George Air Force Base, California

Installation Restoration Program

Final
Operable Unit 3 Record of Decision

November 1998

**Figure
6**

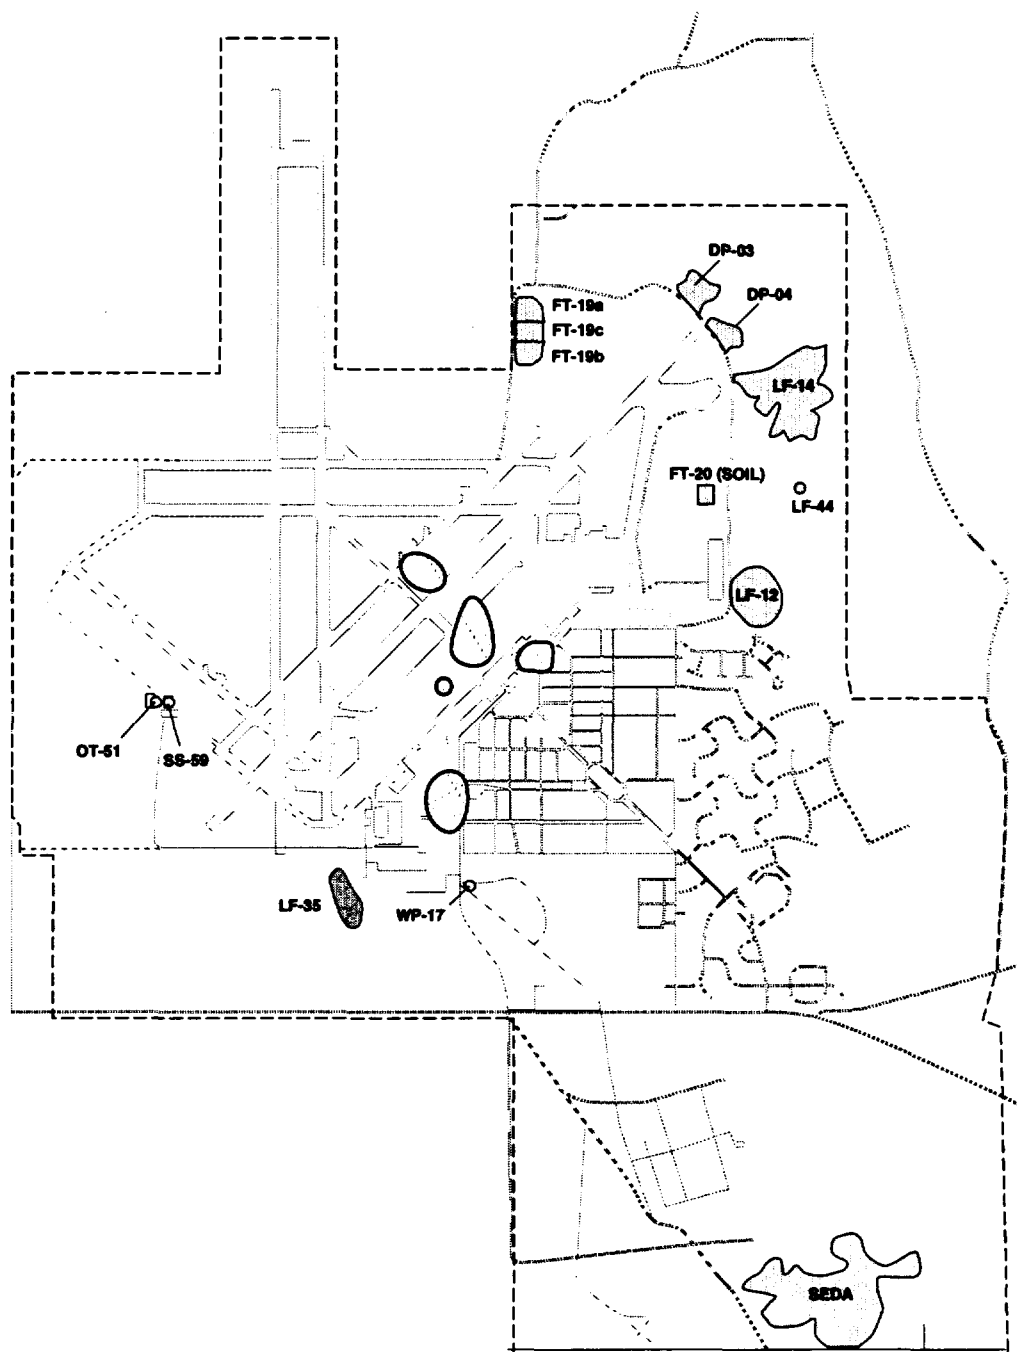
Comment No. 3: For clarity and consistency, Figure 6 should also show the location of LF-35 it was categorized as a site requiring some action.

Comment No. 4: Pg. 2-1, Para 2. The last sentence implies that Figure 6 has all the sites associated with all three Operable Units. This must be revised. In addition, it seems that the sites included on Figure 6 are only those sites which are action recommended. Please include sites LF-35 and OT-69 (groundwater) as well as any sites which have actions recommended.

Response: Site LF-35 has been added to Figure 6.

Response: The text now refers to Figure 2 which presents all three Operable Units. Sites LF-35 and OT-69 have been added to Figure 6.

MONTGOMERY WATSON
 GEORGE AIR FORCE BASE
 REMEDIATION GOALS FOR SOILS
 AT THE OU 3 TPH/VOC SITES

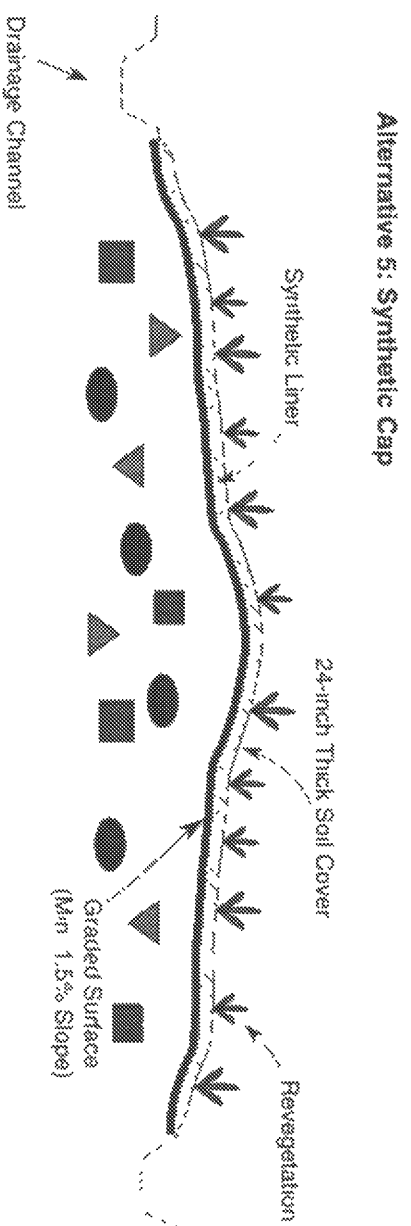
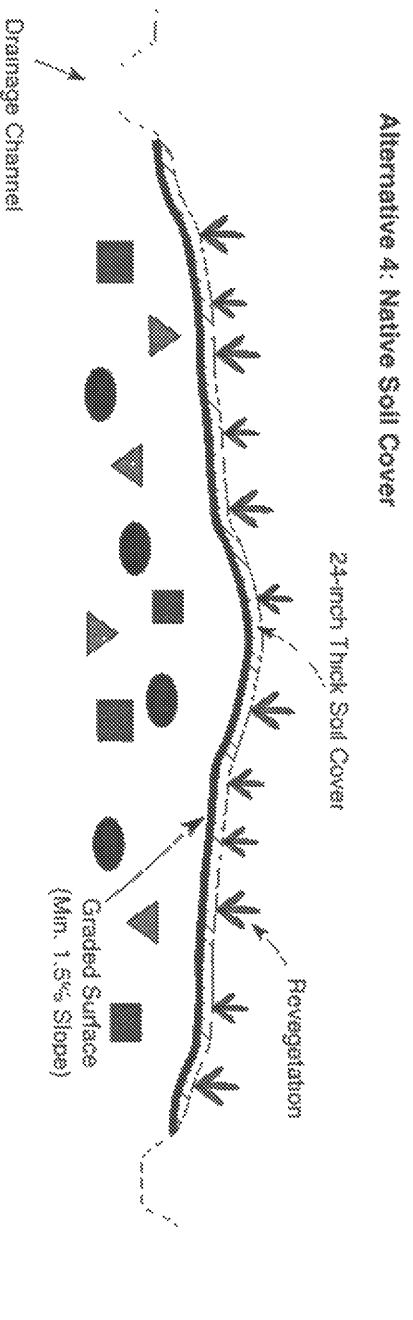
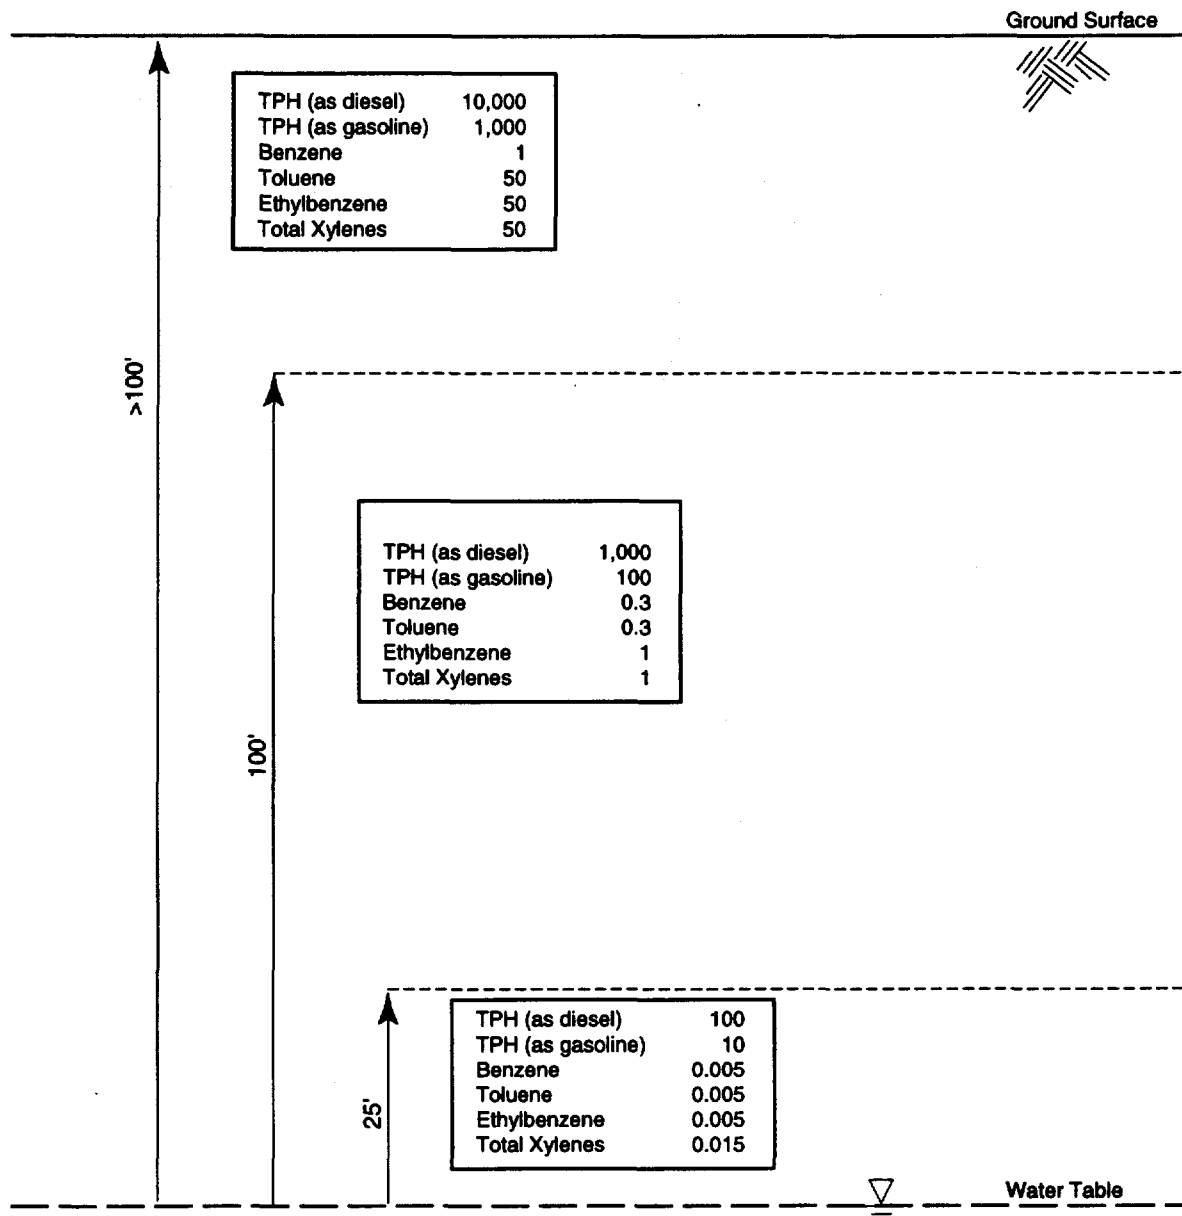
Comment No. 11: **The ROD must indicate that collection of confirmation samples at Sites WP-17, OT-51, and FT-19 is required to verify that the soil cleanup levels indicated in Figures 9 and 10 are attained. Please correct the 20 foot above ground water cleanup level shown on figure 10 from 125 µg/kg to the correct numerical value.**

Comment No. 2: **Page 2-52, para. 5. This section addresses groundwater protection levels as outlined in Figures 9 and 10. Two revisions must be made to this section:**

Comment No. 2: Page 2-53, Section 2.6.2, Description of TPH/VOC Site Alternatives. Please change the last sentence of the paragraph on this page as follows. "Prior to closure of a TPH/VOC site for which a remedy has been implemented, confirmation samples (soil or vapor [to estimate soil concentrations]) would be collected as necessary to demonstrate that *no further impact to groundwater remains using the soil levels presented in Figure 9 and 10 as a goal* ~~soil cleanup levels present on Figure 9 are achieved.~~" As indicated in the prior sentence, site closure is dependent on threat to water quality and the numerical levels shown in the figures are a goal to meet the cleanup objective.

Response: As agreed during the December 23, 1997 RPM meeting, the text has been modified as follows: "Prior to closure of a TPH/VOC site for which a remedy has been implemented, confirmation samples (soil and vapor) would be collected as necessary to demonstrate that soil cleanup levels presented on Figures 9 and 10 are achieved. If contamination remaining in soil can be demonstrated to have no impact to groundwater quality, concentrations remaining in soil may exceed the numerical values presented in Figures 9 and 10, and the site may be considered for closure."

FIGURE 9

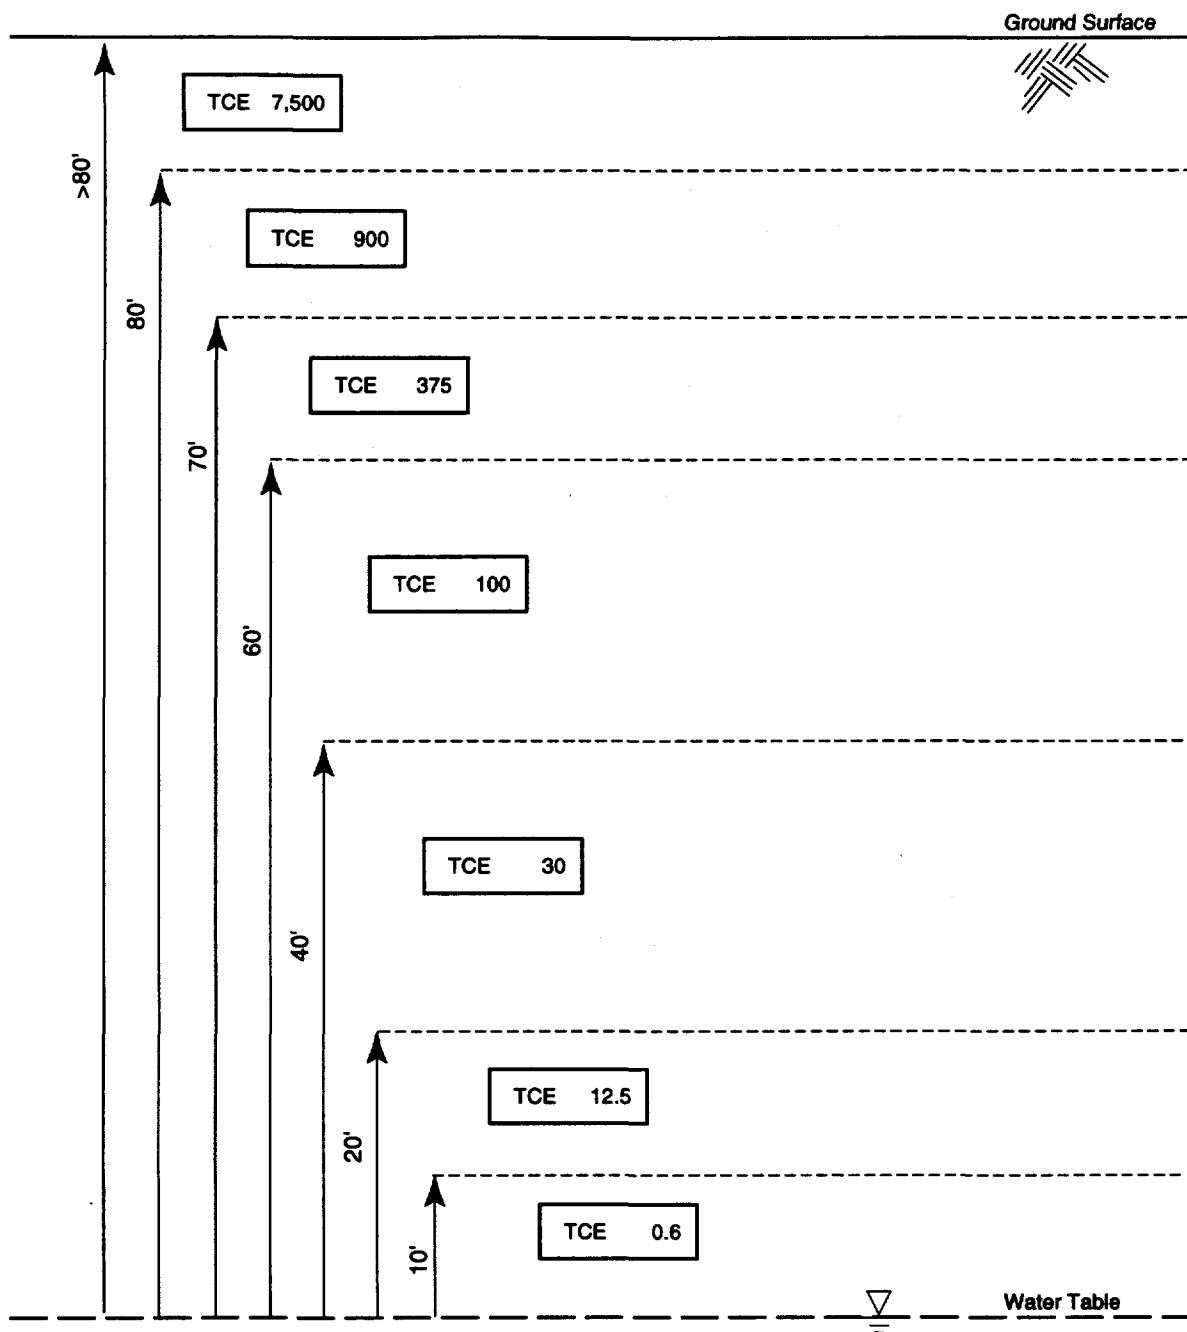
- Comment No. 35:** **Pg. 2-50, Para. 4. Figure 10 has a typographical error which shows the cleanup goal for soils 20 feet above the groundwater at 125 µg/kg. This must be corrected.**

Figure 10 has been revised to state the correct value of 12.5 µg/kg.
